ADDENDUM NUMBER 1
for
Oak Creek Water and Sewer Utility, Oak Creek Wisconsin

Pre-selection Documents
for the
Prestressed Concrete Storage Tank

DATE: April 27, 2015

DATE MARCH 2015
PROJ 653463
DWG 40-SD-301
SHEET of

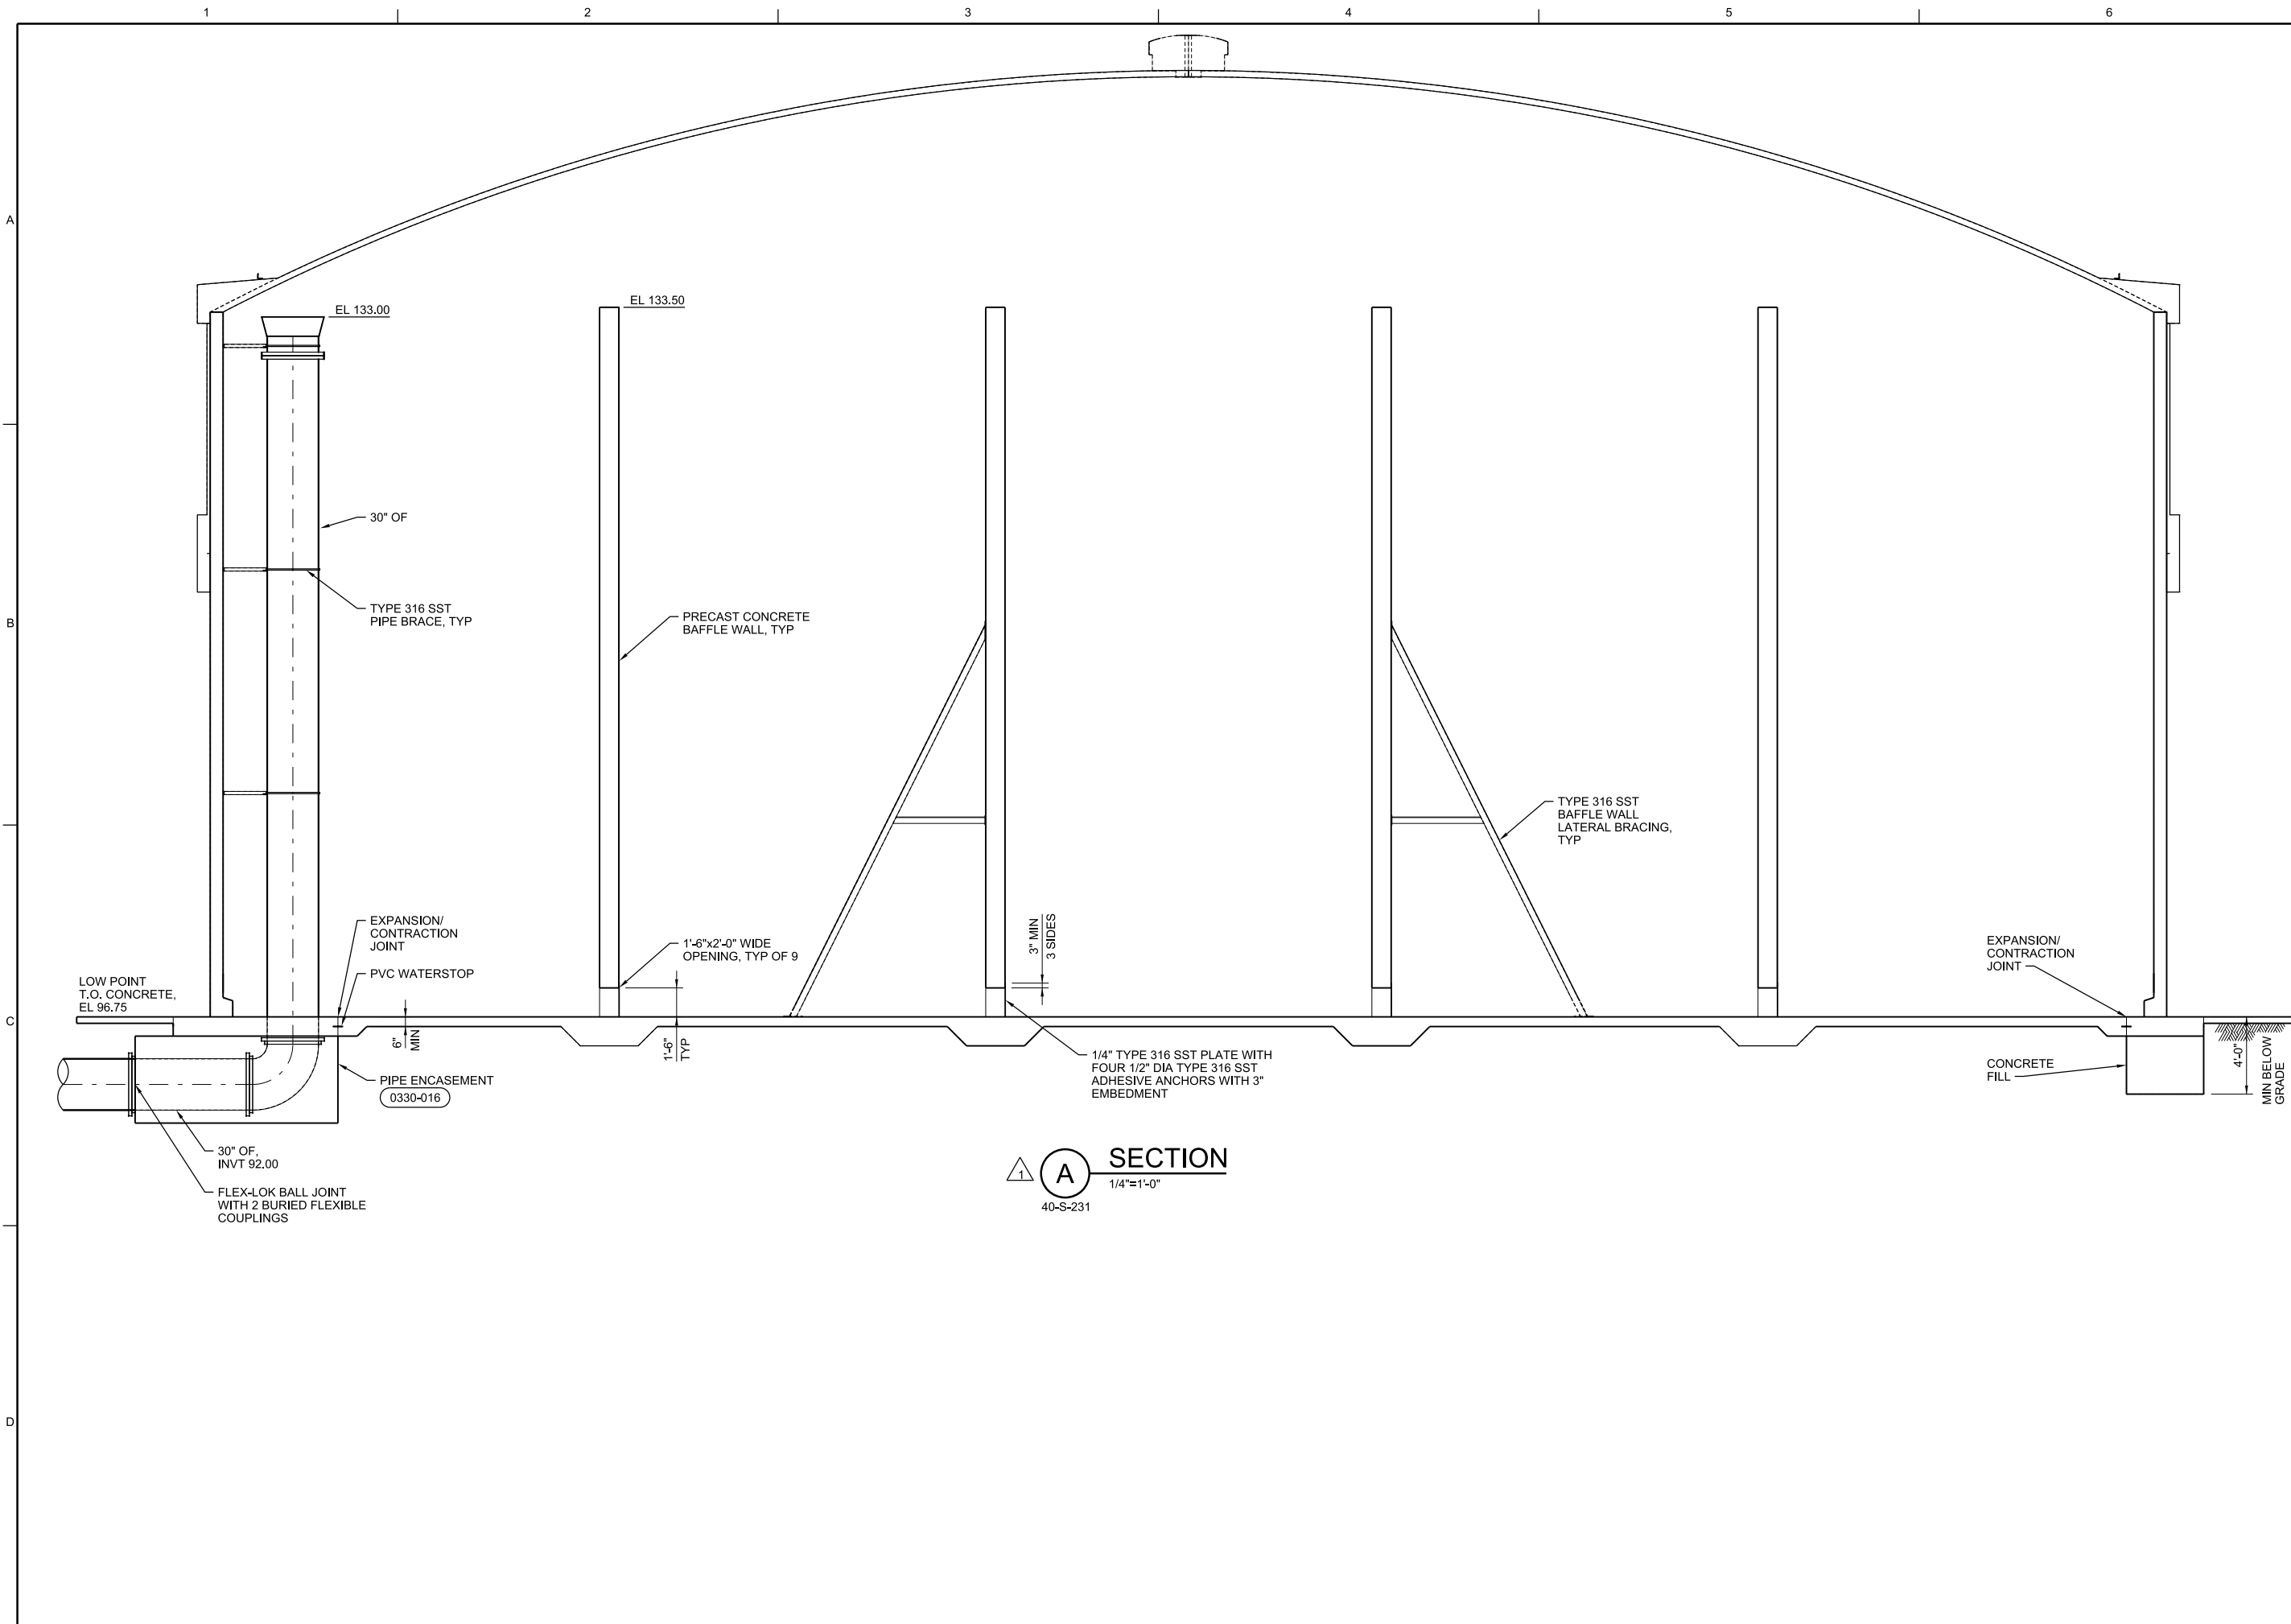
DRAWINGS 40-SD-231, 40-SD-301

1. Replace these drawings with attached revised drawings.

3. Drawing # 40-SD-301 shows a grout pad on top of the 6" concrete floor with the thickness of grout varying from 15" to 2" to develop the slope across the tank floor. It is our experience and opinion that the floor slope is best achieved by sloping the granular leveling base below the 6" floor, instead of using a grout topping. The grout topping, especially one 15" thick, is likely to crack and may not have the required durability. We request that our alternative method of building the floor slope be permitted. Please clarify.

44. Drawing 40-SD-301, we have concerns that the grout topping will restrict the tank wall movement and induce additional stresses into the tank wall and would like to discuss with you other means of accomplishing the desired drainage of the tank floor.

A: The grout is deleted. See revised drawings.
